Chapter 15

Preapproved Wall Appendix: Specific Requirements and Details for LB Foster Retained Earth Concrete Panel Walls

In addition to the general design requirements provided in **Appendix 15-A**, the following specific requirements apply to the design of the LB Foster Retained EarthTM concrete 5 ft x 5 ft panel faced retaining wall:

MSE RETAINING WALL: TYPICAL SECTION
SCALE: N.T.S.

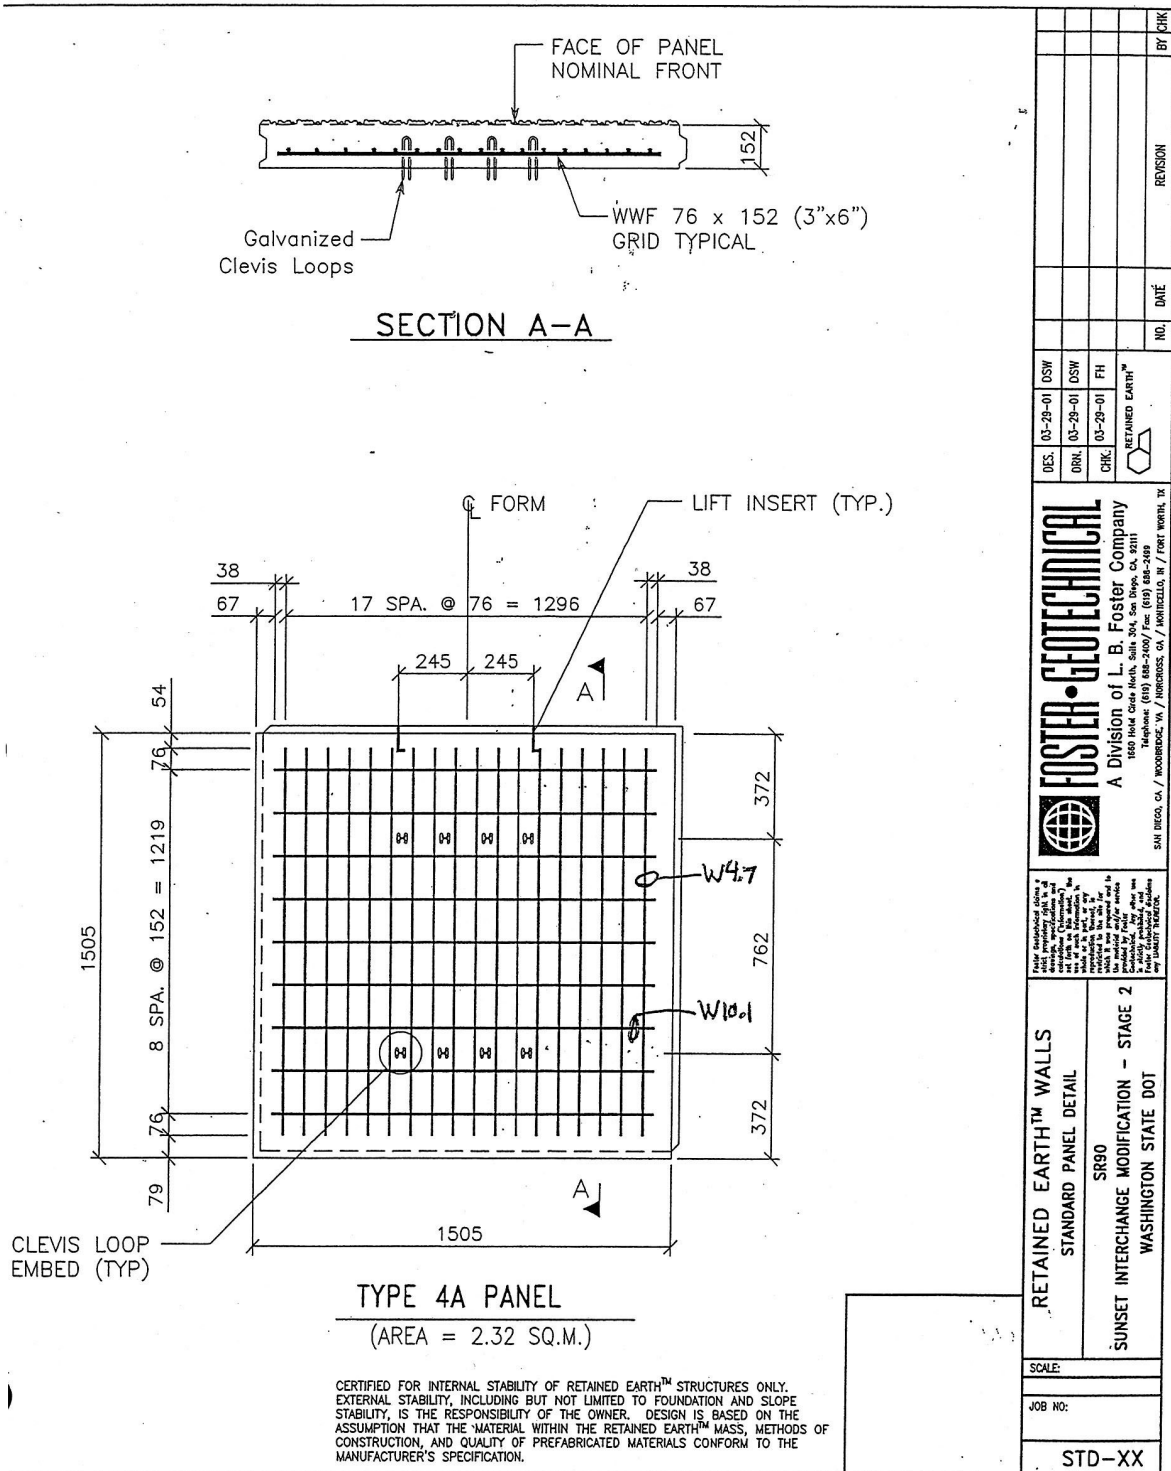
- In the plan sheets on pages 2 and 6, there should be a minimum cover of 4 inches of soil between the steel grid in the soil and the traffic barrier reaction slab.

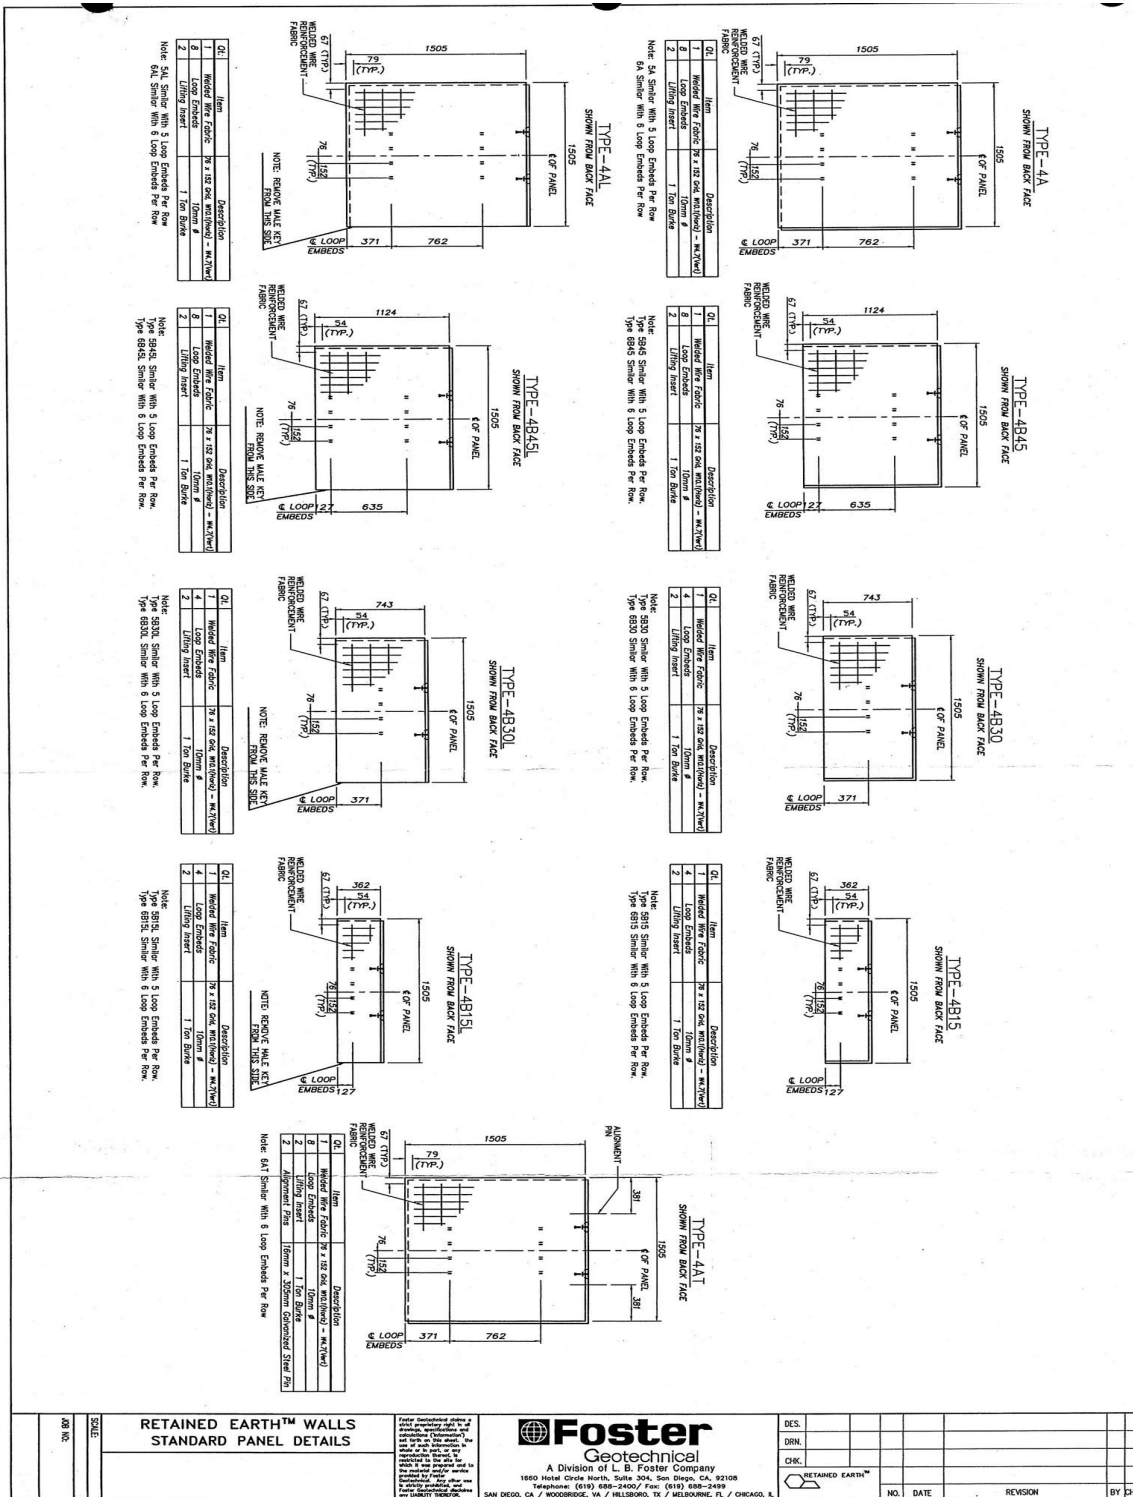
- In the plan sheet on page 7, regarding the filter fabric shown, WSDOT reserves the right to require the use WSDOT Standard Specification materials as specified in Standard Specification Section 9-33 that are similar to those specified in this plan sheet.
